Access Compliance Report Public Rights-of-Way (Curb Ramps)

Main Street: O_NEILL_DR Cross Street: DORRANCE_DR Location: S

ADA ID: RPRK211102131525 Ramp Type: Type 4 - Parallel Initial Pass/Fail: Fail Overall Compliance: No Severity Score: 15

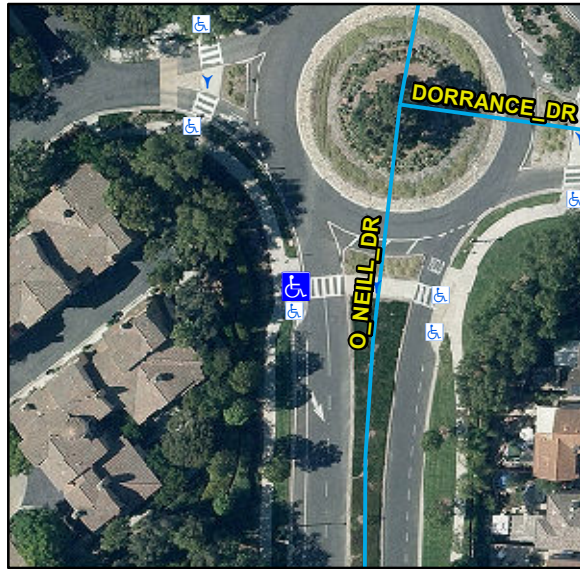
Compliance	Description	Data	Compliance	Description	Data
N/A	Ramp Length LT (in)	-9999	N/A	Ramp Length RT (in)	96
N/A	Ramp Width LT (in)	-9999	Yes	Ramp Width RT (in)	48
N/A	Ramp Run Slope LT (%)	-9999	No	Ramp Run Slope RT (%)	9.7
N/A	Ramp Cross Slope LT (%)	-9999	Yes	Ramp Cross Slope RT (%)	1.9
N/A	Landing Present	N/A	N/A	DWS Provided	N/A
N/A	Landing Length (in)	N/A	N/A	DWS Contrast	N/A
N/A	Landing Width (in)	N/A	N/A	DWS Length (in)	N/A
N/A	Landing Run Slope (%)	N/A	N/A	DWS Full Width	N/A
N/A	Landing Cross Slope (%)	N/A		DWS Offset Type	N/A
N/A	Landing Movement Obstructed?	N/A	N/A	DWS Offset Left (in)	N/A
	Landing Movement Type	N/A	N/A	DWS Offset Right (in)	N/A
N/A	Landing Shared	N/A			
N/A	Clear Space	N/A			
N/A	Clear Space To Crosswalk (in)	N/A			
N/A	Marked Crosswalk 1	Yes	N/A	Marked Crosswalk 2	N/A
	Crossing 1 Direction	E		Crossing 2 Direction	N/A
	Marked Crosswalk 1 Width (in)	144		Marked Crosswalk 2 Width (in)	N/A

Remove & Replace Entire Ramp.

R304.3.2, STD 1115
